Mayor Hemminger and members of Town Council:

Eastowne Project - Illustrations from application materials Original Concept Plan

Town of Chapel Hill: Traffic Impact Study
UNC Health Care Eastowne Medical Office Building - Proposed Redevelopment

Current Site Plan – Note dotted lines for parking deck expansion into RCD, 380 foot parking deck with only entrance to property through the deck.

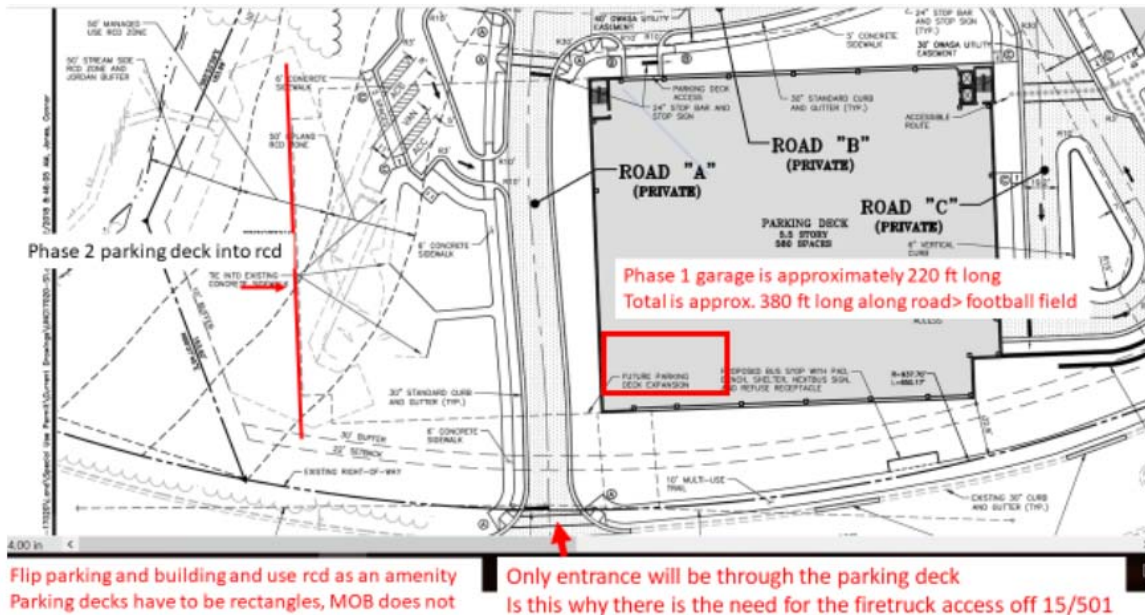
Illustrates two buildings along 15-501, a parking deck and possible third building on the surface parking lot space.

Per the application, the two front buildings will share a screened service functions area at ground level in the gap.

Parking deck extends into second level of RCD (red line on the left)

Unclear if deck expansion would require further approval since 1) it is on the plan and 2) unconditioned space does not count in floor area ratio

Current Site Plan:

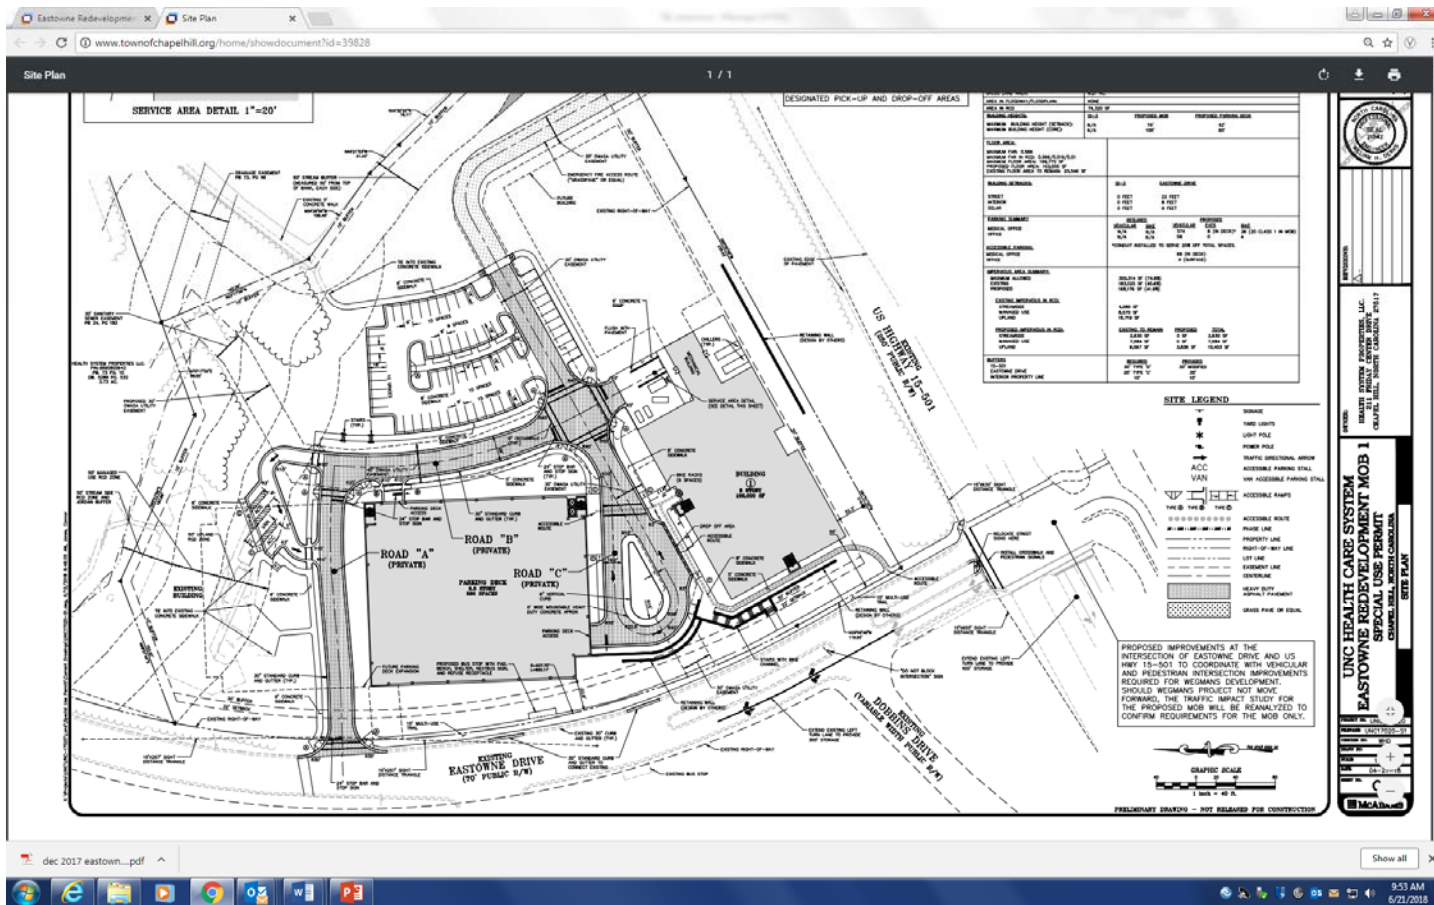
Inclusion of second building pad for clearance is on plan despite “Phase I only” request FAR does not allow for second 150,000 sqf building

O13 allows up to 199,700

Resulting building length on 15-501 of 480’ with no first floor break

No documentation in presentation materials from staff to explain that “six story” building height is 95’ tall (typically equivalent to 8 – 9 stories)

Am peak trip graph

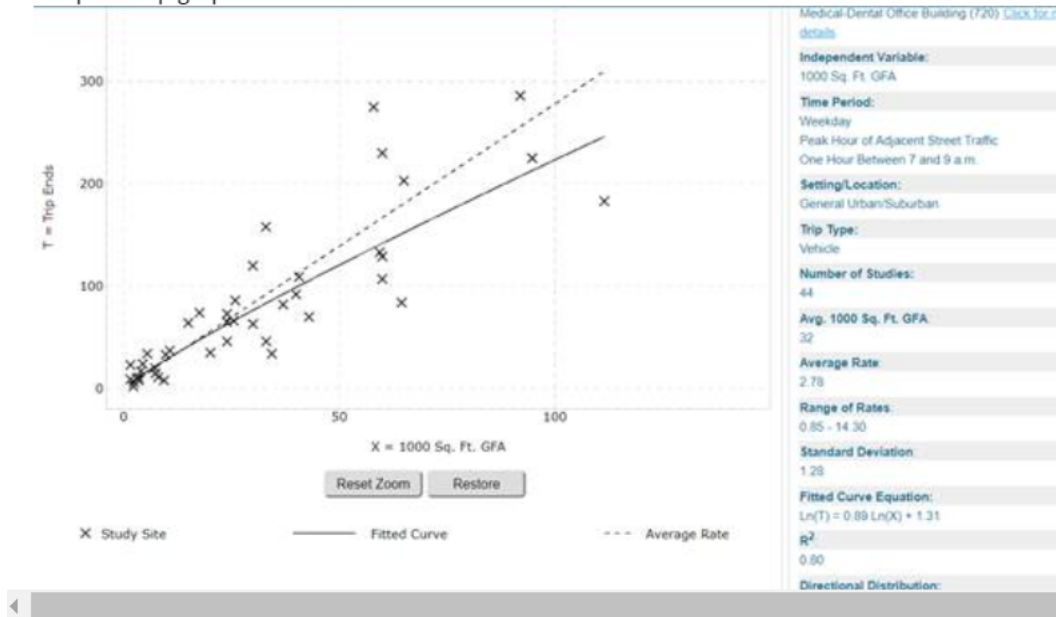
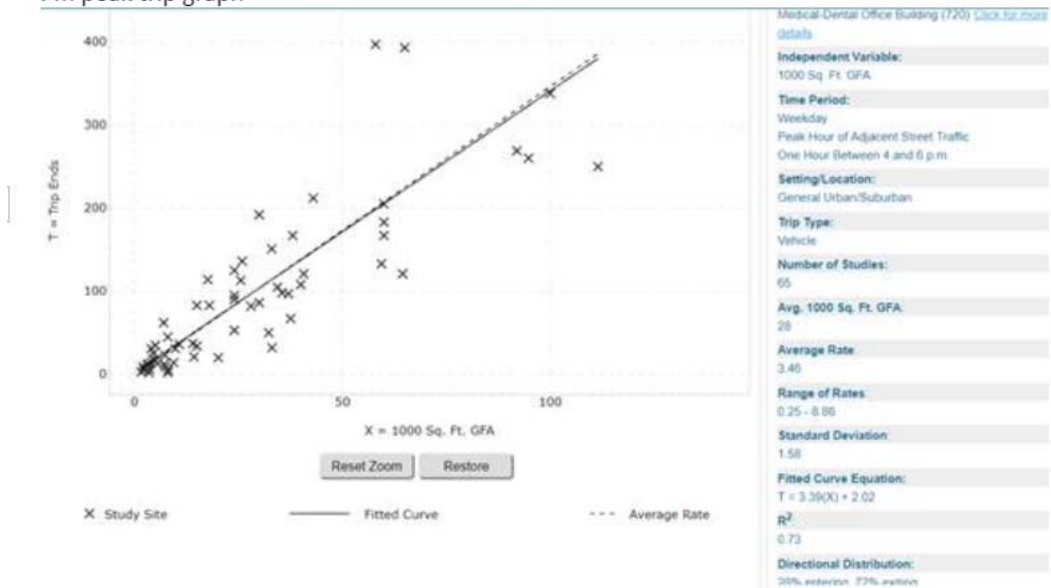
* TIA is showing only 230 am and 237 peak pm trips. You will see from the graphs below that this is more equivalent to a 70-100k sf building not a 150k sf building.

Not compute the am and pm peaks from the ITE graphs below to the tabel the applicant submitted in the TIA. It is low by 30-50%.
